Ohio Museum Complex HVAC  
Lin Hall, The Ridges – Ohio University  
Athens, Ohio

## ADDENDUM 01 - REBID

Addendum to the drawings and specifications for: **Ohio Museum Complex HVAC**

**H6**

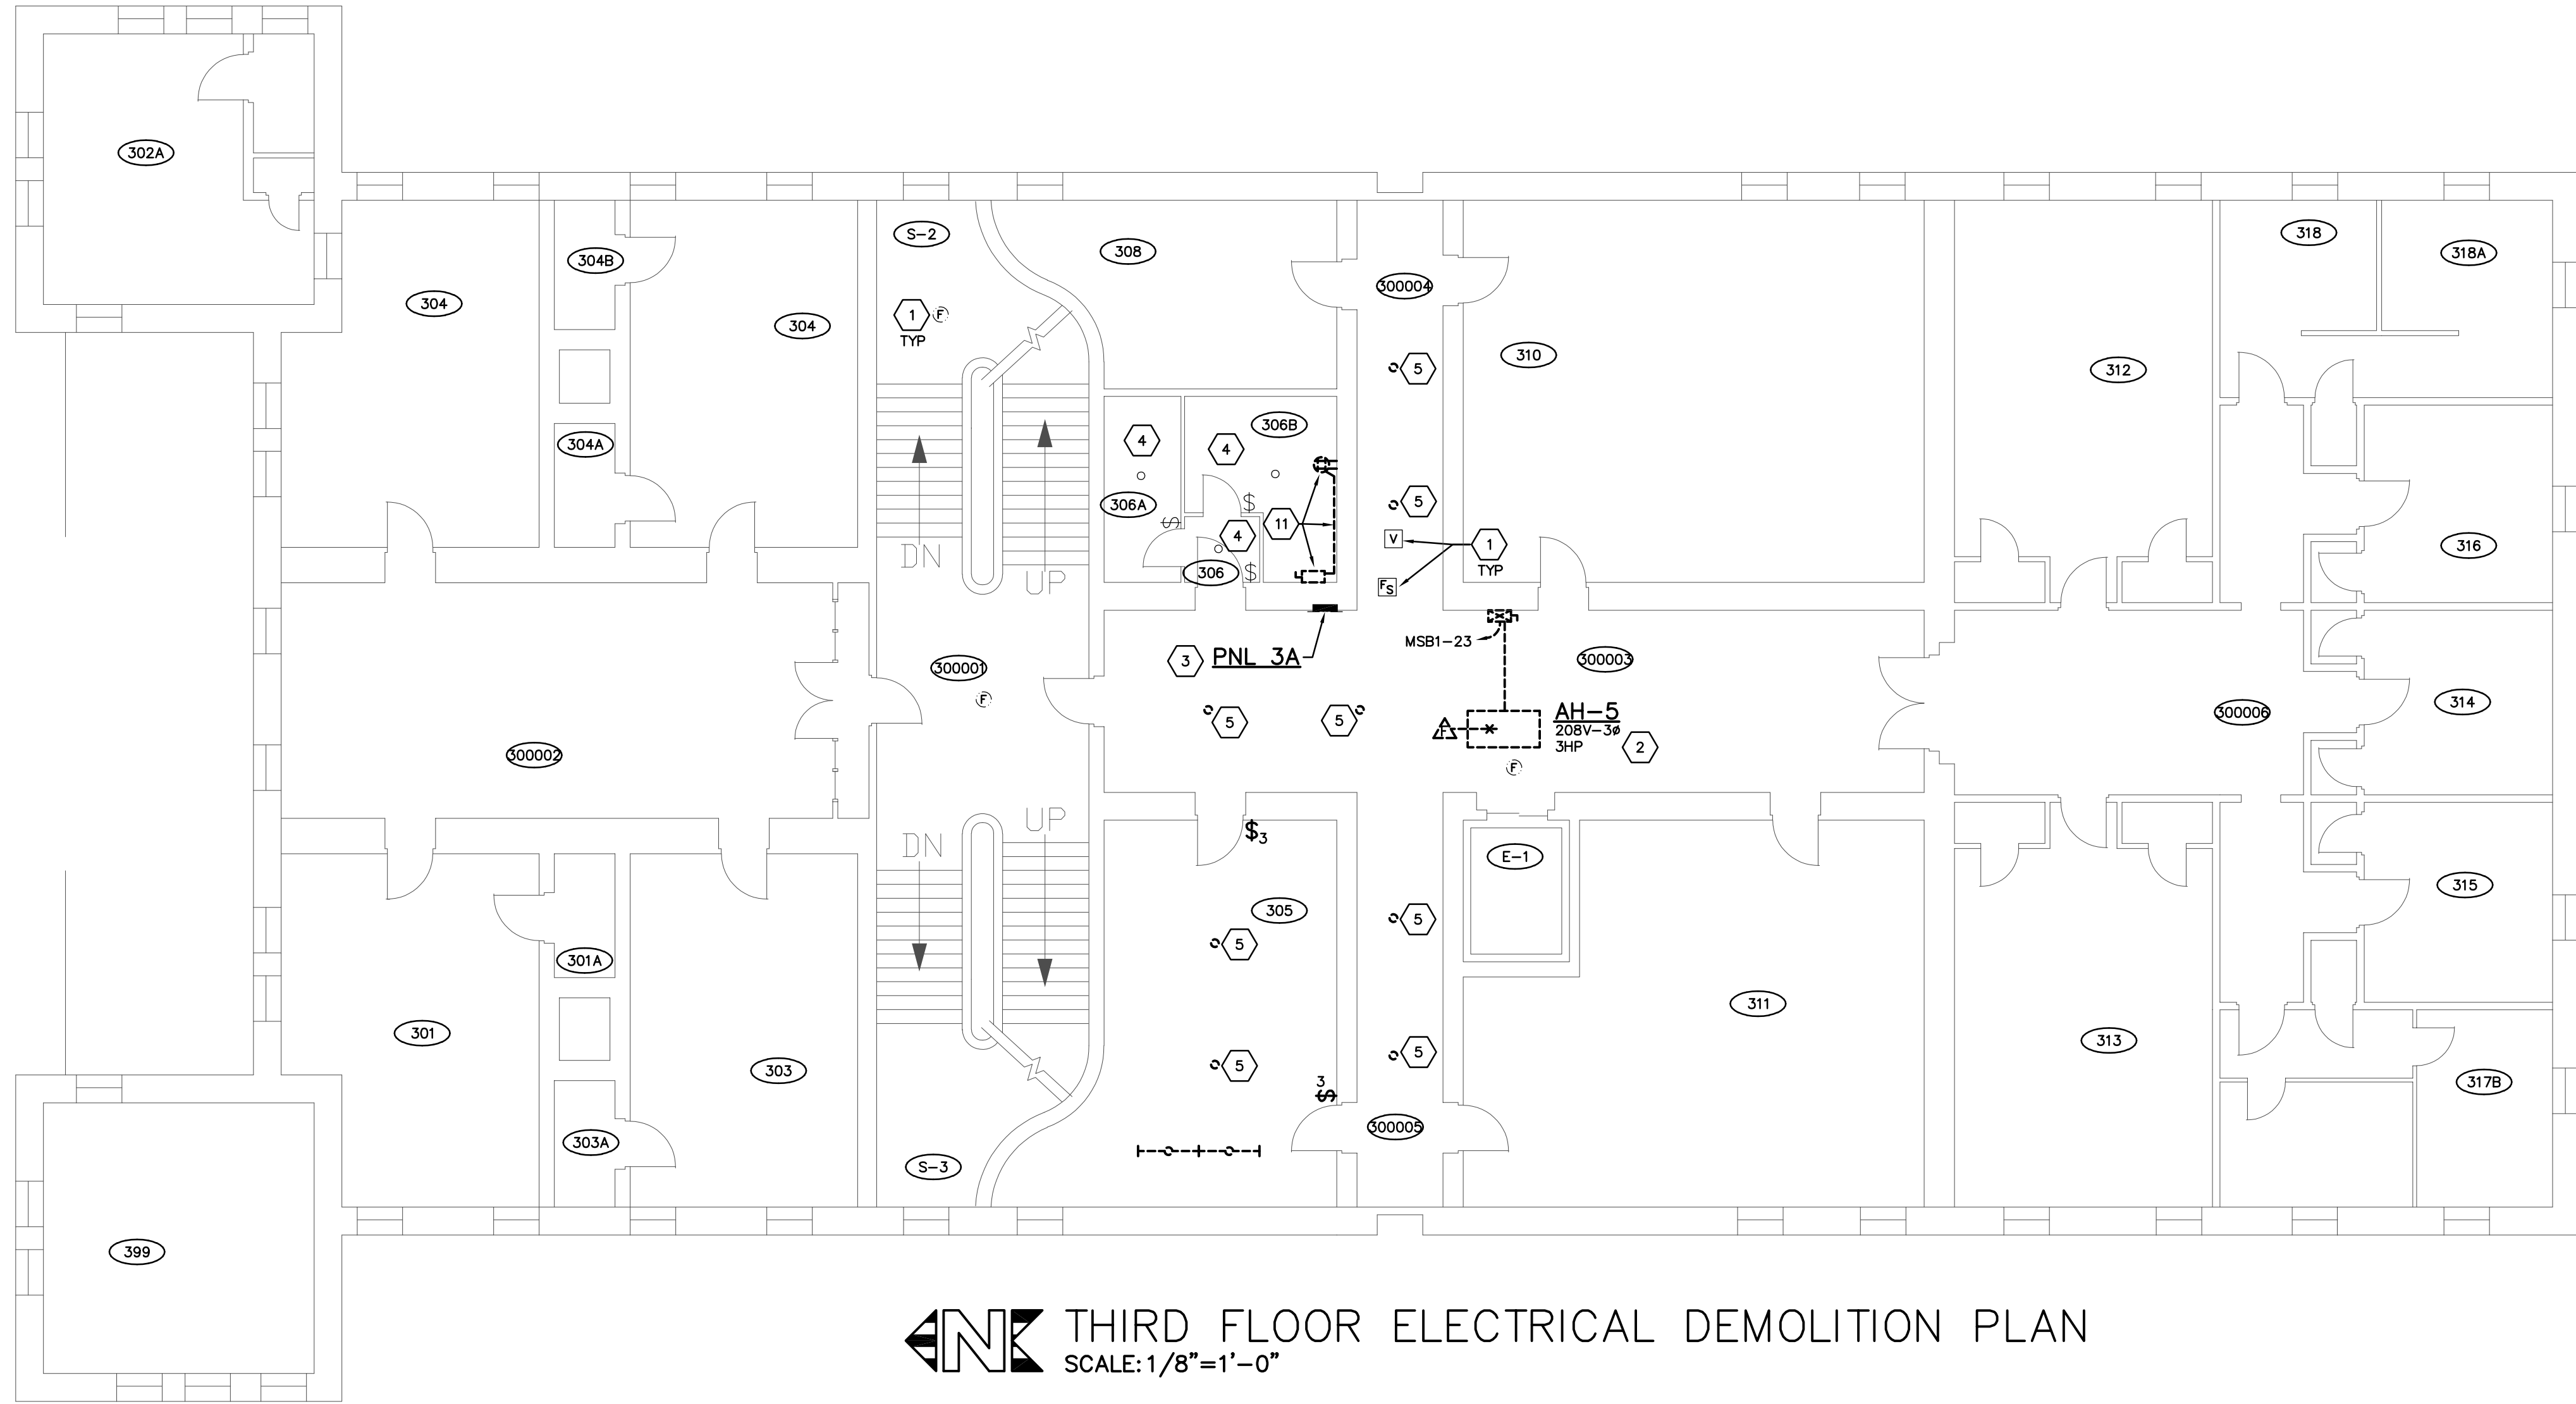
5. Are the filtration units still an alternate bid?  
*PEA Response: The polarized media filtration units are no longer included as an alternate in the bid. The schedule notes and the equipment notes shall be deleted from the bid. Specification section 23 75 05 shall be deleted from the project documents.*
6. Are the humidifier units still an alternate bid?  
*PEA Response: Yes, the electrode type humidifiers and softened water supply piping are still a part of the bid. This shall be Alternate H-1 since the filtration system alternate has been deleted. See revised drawing Sheet H-6.*

9. Note #44 on sheet H6 says cross hatched duct is to be double wall. There is no cross hatch duct on the plans.  
*PEA Response: Double wall duct was deleted from the scope. See revised sheet H6.*

- DELETED NOTE FOR CROSS-HATCHED DUCT.

- COOLING COIL TOTAL 320 MBH, SENS. 240 MBH
- UNIT MCA = 12; MOCP = 15A  
VFD FURNISHED BY MECH. CONTR.
- DELETED BY ADDENDUM #1
- DELETED BY ADDENDUM #1
- BASE BID FILTRATION IS STANDARD MIXING BOX WITH INTEGRAL MOTORIZED DAMPERS FURNISH WITH MERV 13 CARTRIDGE FILTERS

- AF-5-6 AIR FILTRATION UNITS - DELETED BY ADDENDUM**
- H-9 AND H-10 HUMIDIFIER**  
 CONSIDER ELECTRIC HUMIDIFIER MODEL EL 30. EACH UNIT TO DELIVER STEAM TO PROCESS 3000 CFM FROM 85° AND 39.2 GR/LB ABSOLUTE HUMIDITY TO 72° AND 50.2 GR/LB ABS. HUMIDITY (435 RH AIR DELIVERED TO SPACE). 208V/3PH/60HZ, 11.25 KW, FURNISH WITH DUCT DISTRIBUTION ACCESSORIES TO MATCH DUCT SIZE AND ABSORPTION DISTANCE REQUIREMENTS FOR DUCT LOCATION. REFER TO SPECIFICATIONS SECTION 2318 29.13.

DELETED FAN SCHEDULE NOTES 3,4,5
